TECHNICAL BULLETIN

LTB00504v3

This bulletin supersedes TSB LTB00504v2/2013 dated 14 JAN 2013, which should either be destroyed or clearly marked to show it is no longer valid (e.g. with a line across the page). Only refer to the electronic version of this Technical Bulletin in TOPIx.

Compressor Shut Off Valve (CSOV) Lower Level Repair

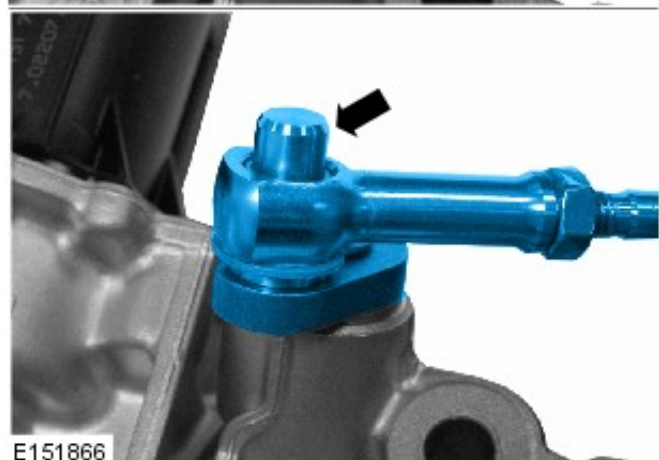
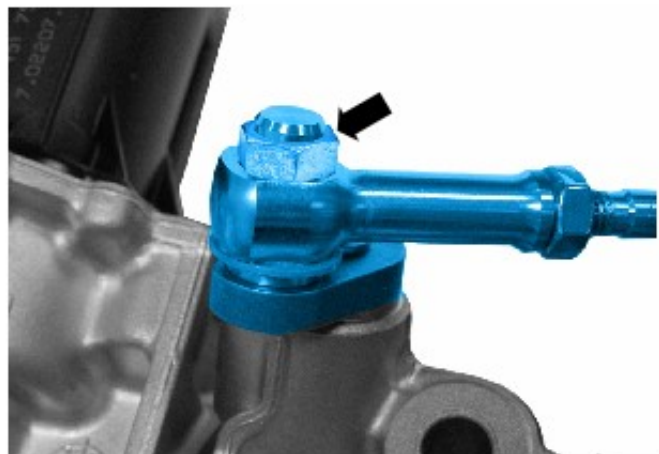
1. In addition to the bush, the pin is now plain without the retention nut, if no retention nut is fitted as per lower graphic in E151866 the vehicle has the latest csov fitted with the latest level linkage arm and this TSB does not apply. This TSB only applies to CSOV assemblies with a retaining nut fitted on the link arm as shown in the upper graphic.

E 138286

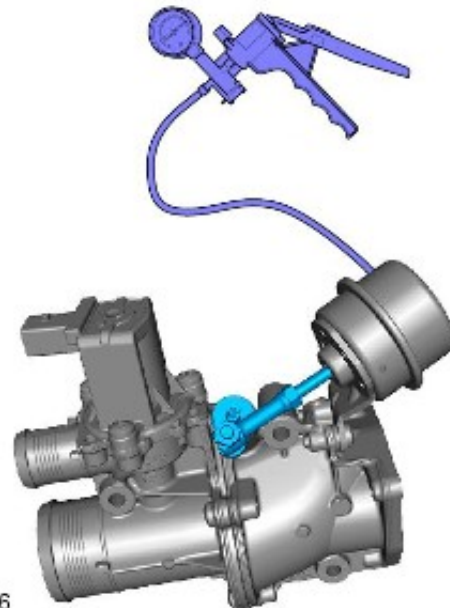
Using a vacuum gauge, make sure the valve arm fully and smoothly retracts when full vacuum is applied. when vented the valve should quickly close.
